SUBJECT: Forwards open items from Structural Engineering Branch
 811005-08 meeting in Woodbury, NY.

Subject: NUCLEAR PROJECT NO. 2
OPEN ITEMS FROM SEB MEETING

Attached are sixty copies of the open items from the Structural Engineering Branch meeting held in Woodbury, New York, October 5 - 8, 1981.

WNP-2
NRC-SEB MEETING

----- 3 COMPONENT SRS

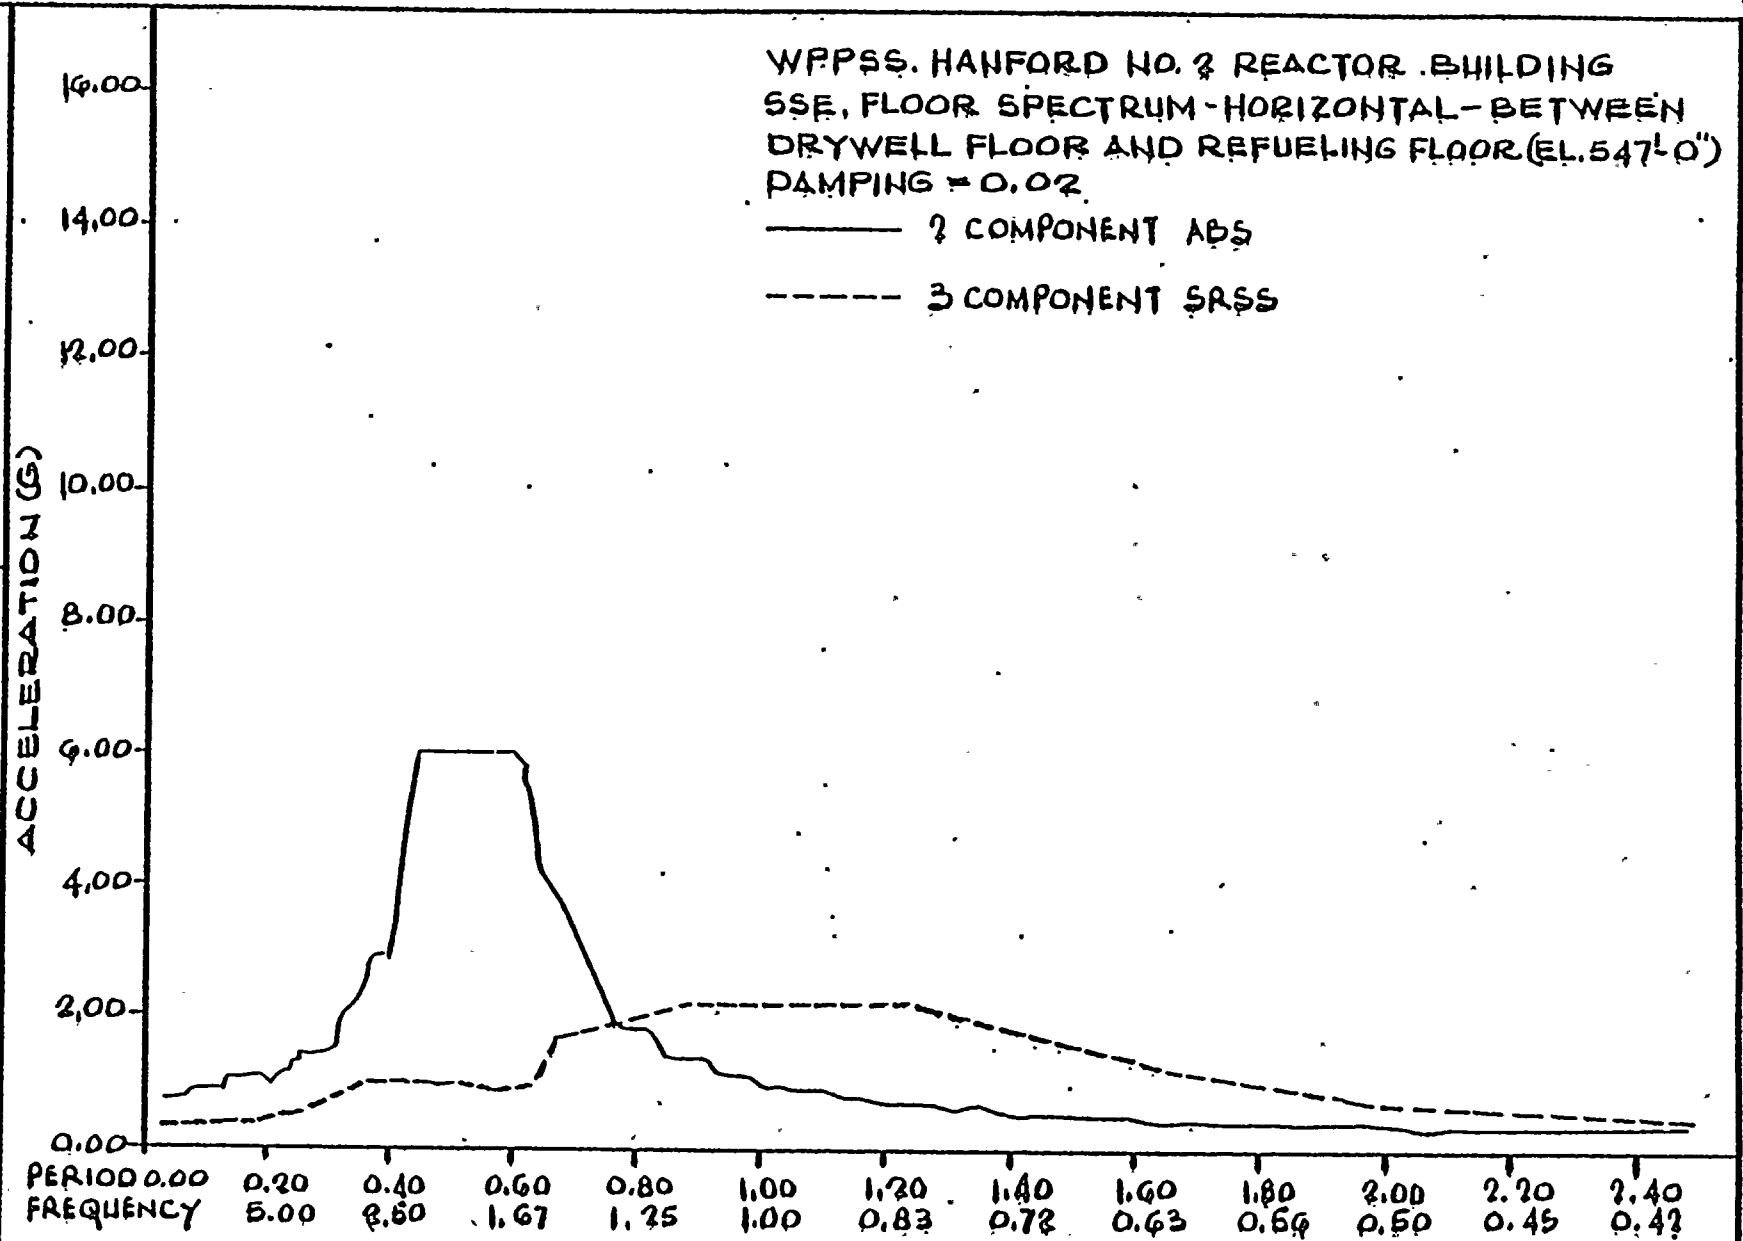
A comparison of building response spectra between the two component earthquake motion (absolute sum method) and the three component earthquake motion (SRSS method) are provided in Figures 130.056-1 through 130.056-7 for the following locations:

The comparison of response spectra clearly demonstrate that the original design basis (2-D method ABS) is more conservative than the SRSS/3 component method for all frequencies larger than 1.25 Hz. In the frequency range of interest/concern in the WNP-2 design (approximately greater than 5 Hz) the margin of conservatism is very significant.

WASHINGTON PUBLIC POWER SUPPLY SYSTEM
 NUCLEAR PROJECT NO. 2
 3-D MATH MODEL FOR
 REACTOR BLDG (NE) (W)
 FIGURE
 3-3

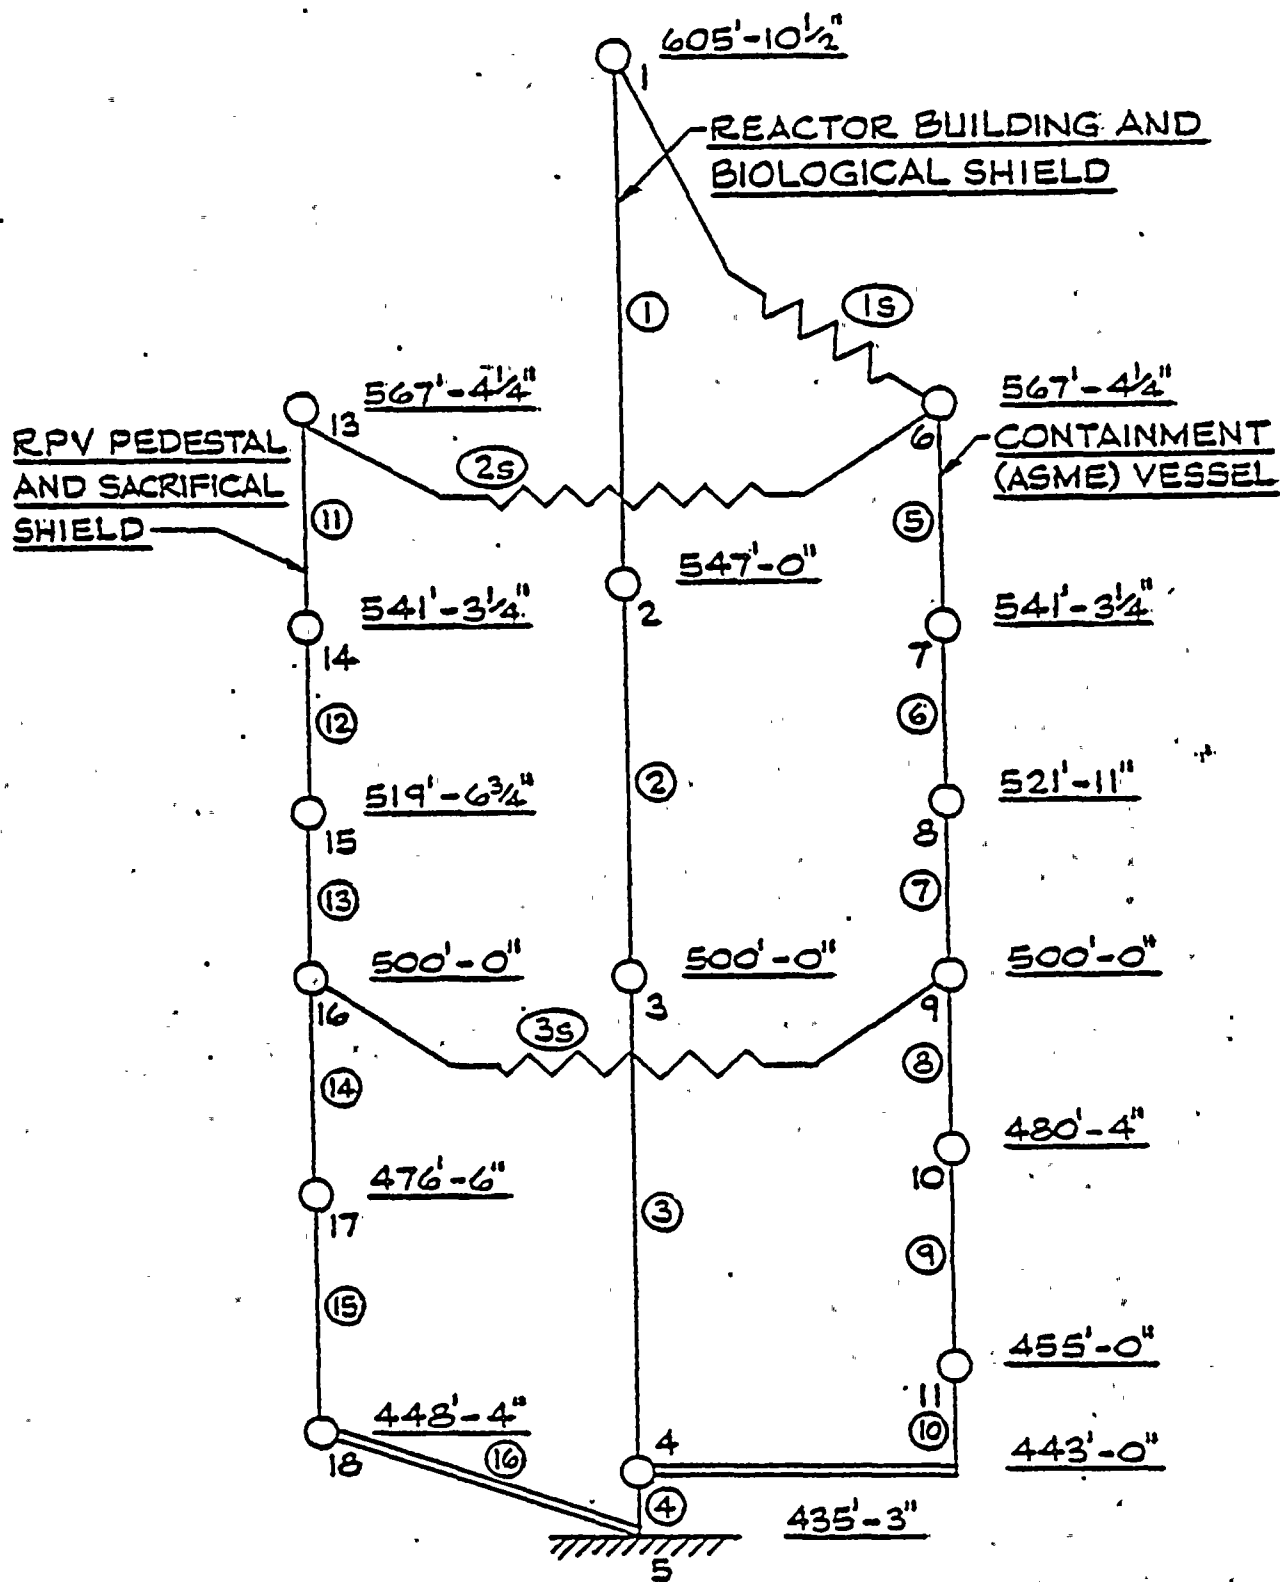
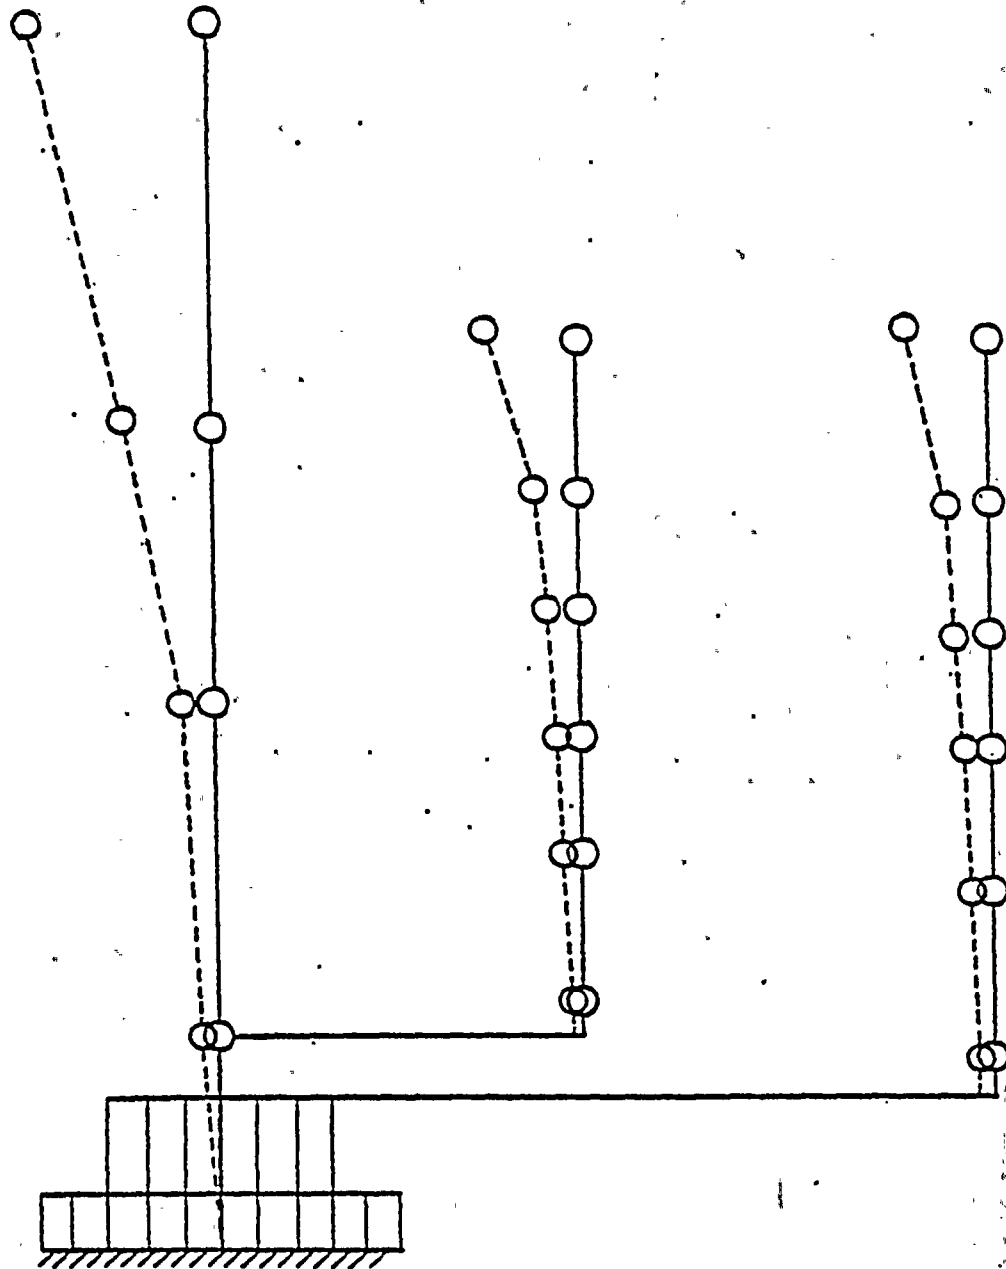
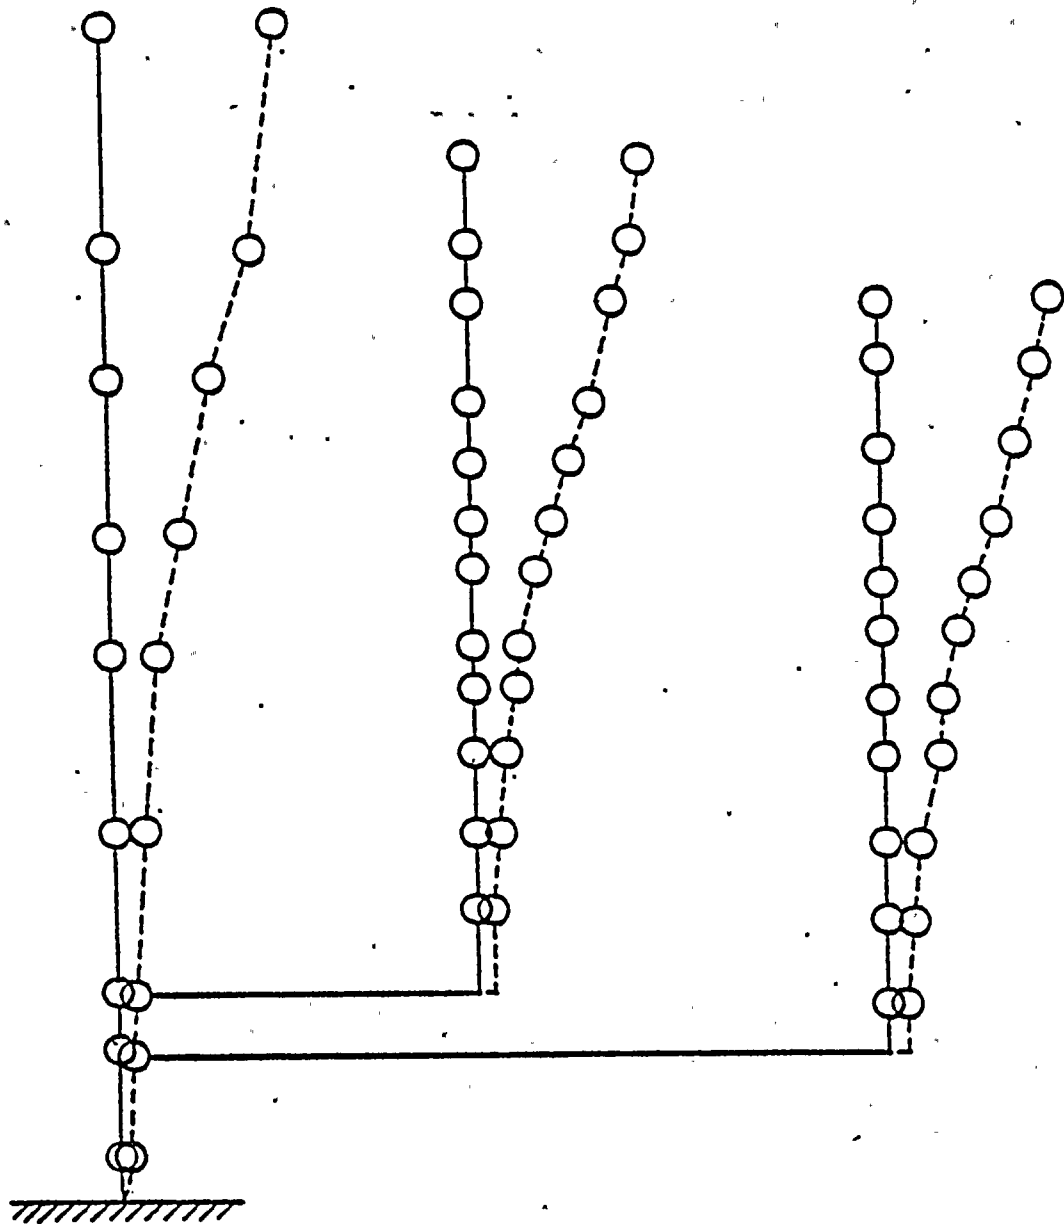
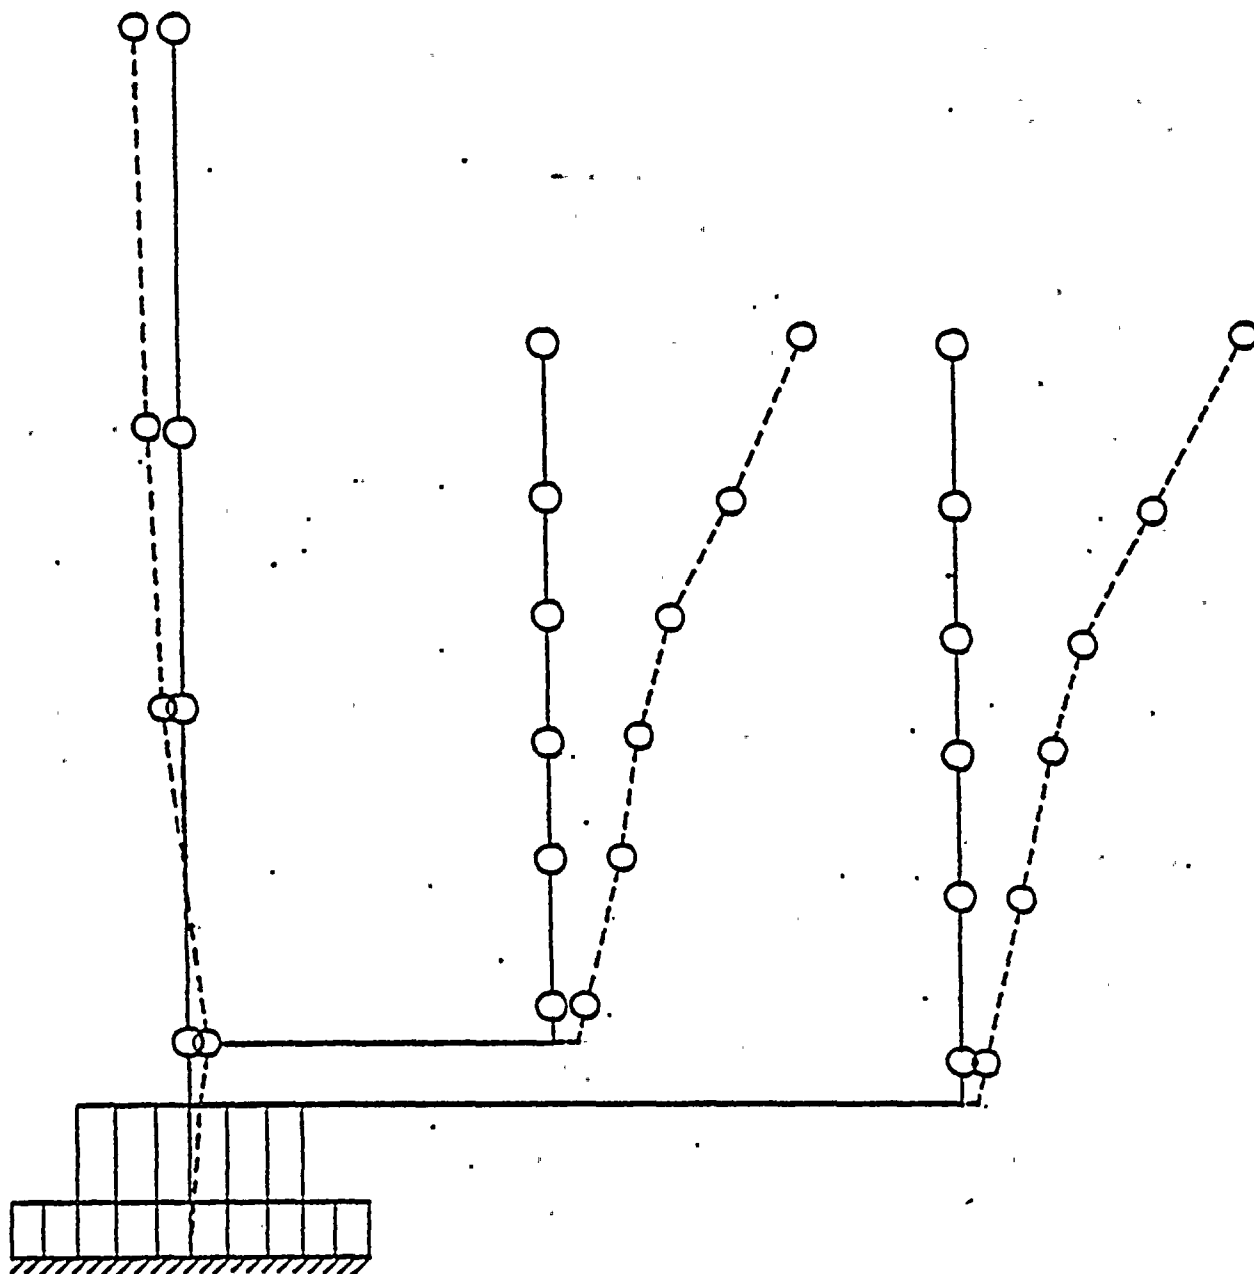
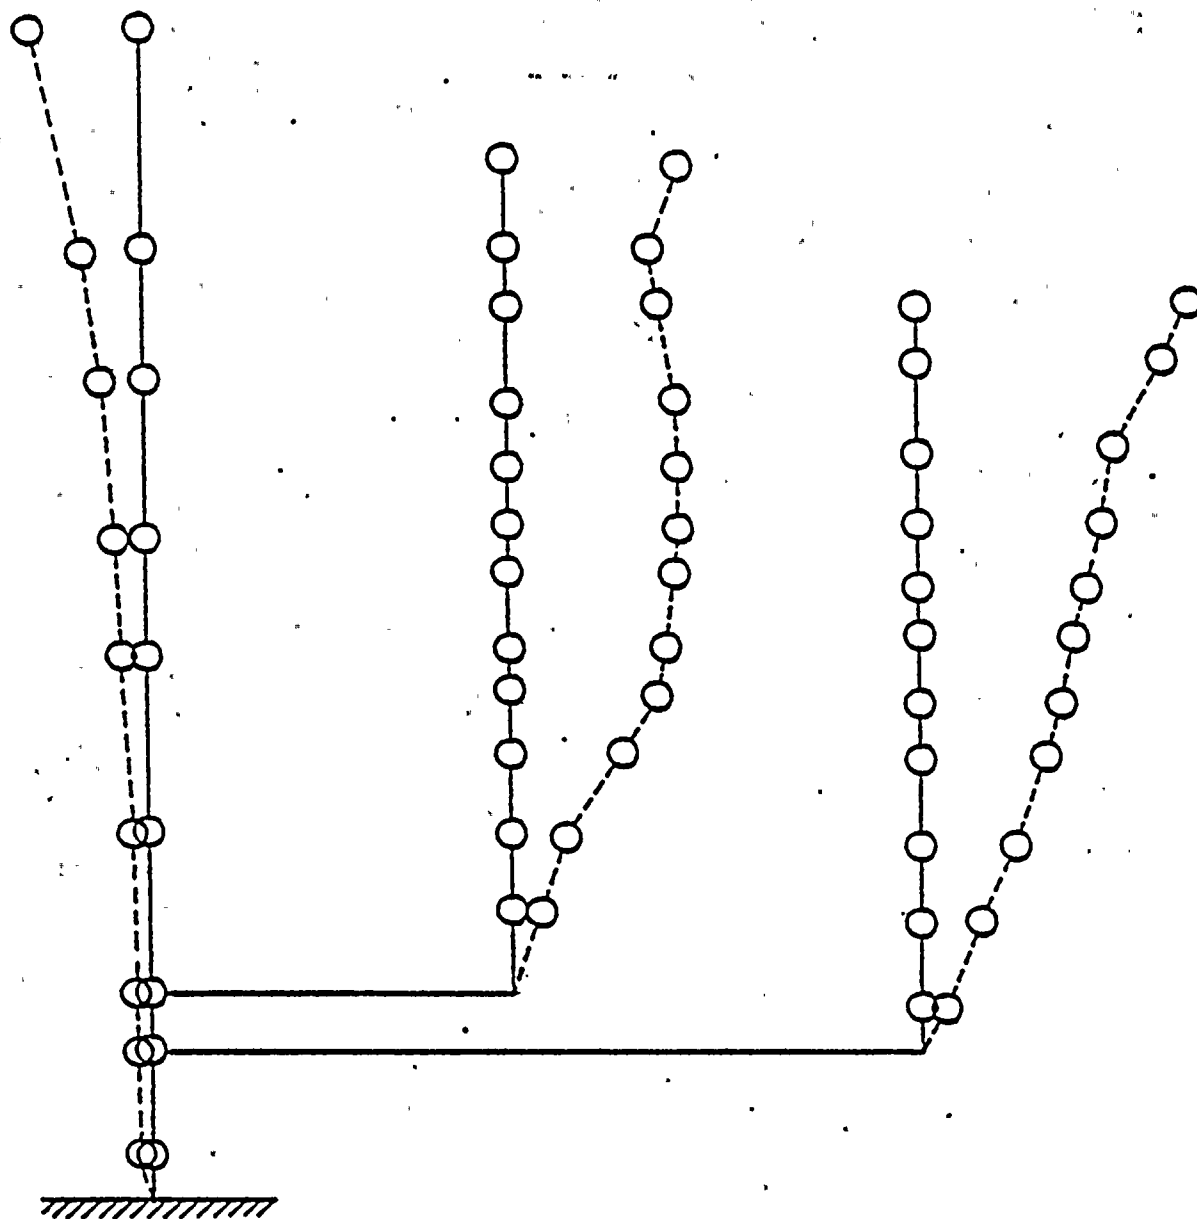
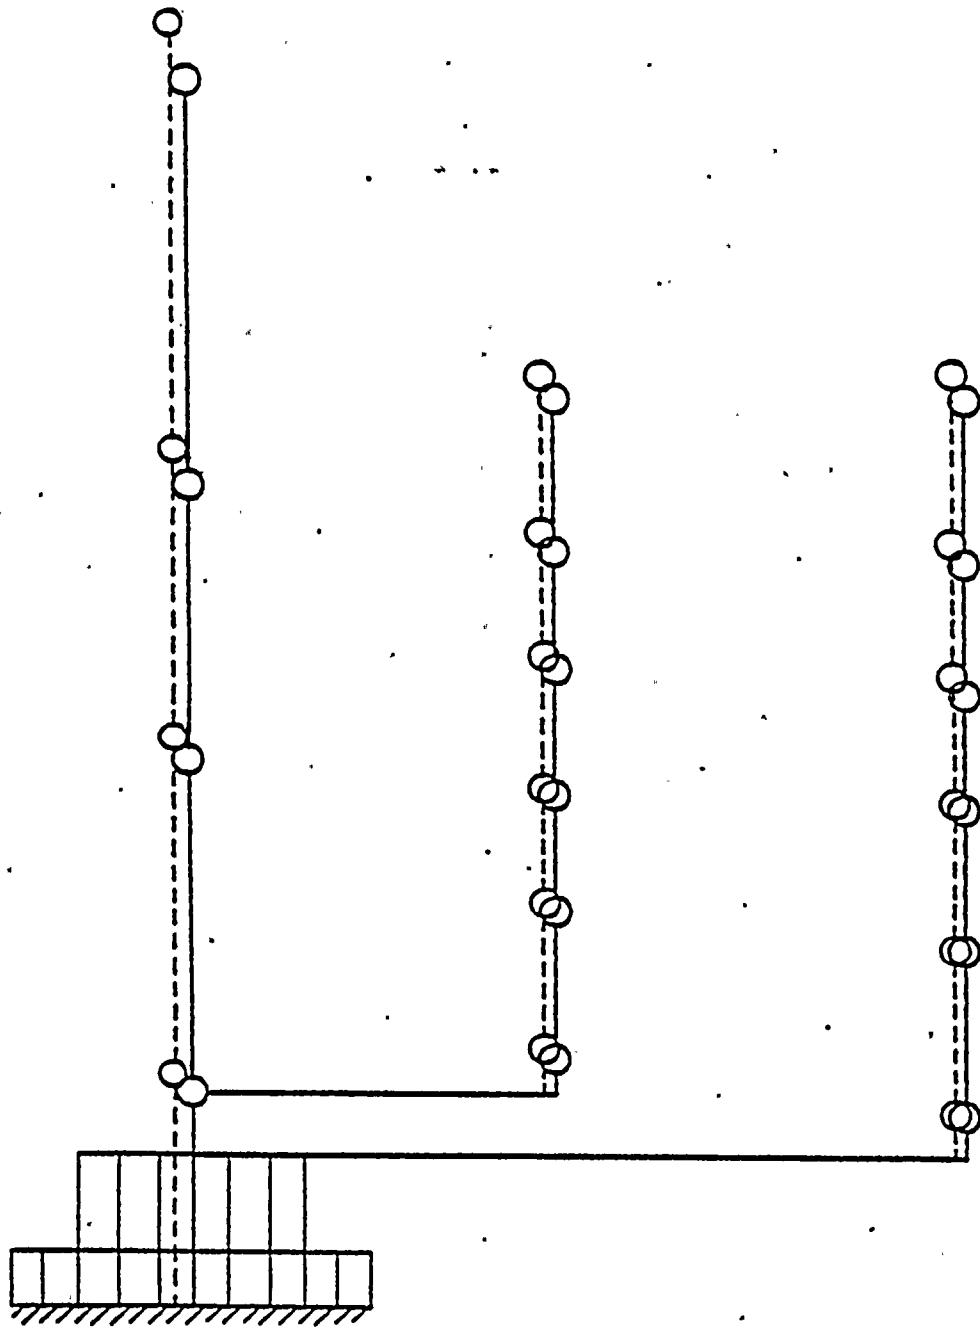
RESPONSE

The reduced (simplified) and full models of the reactor building are shown in the figures attached. An eigen value solution was obtained for each model and corresponding natural frequencies and natural mode shapes are compared. The good agreement noted indicates the equivalence of the two models for the reactor building.
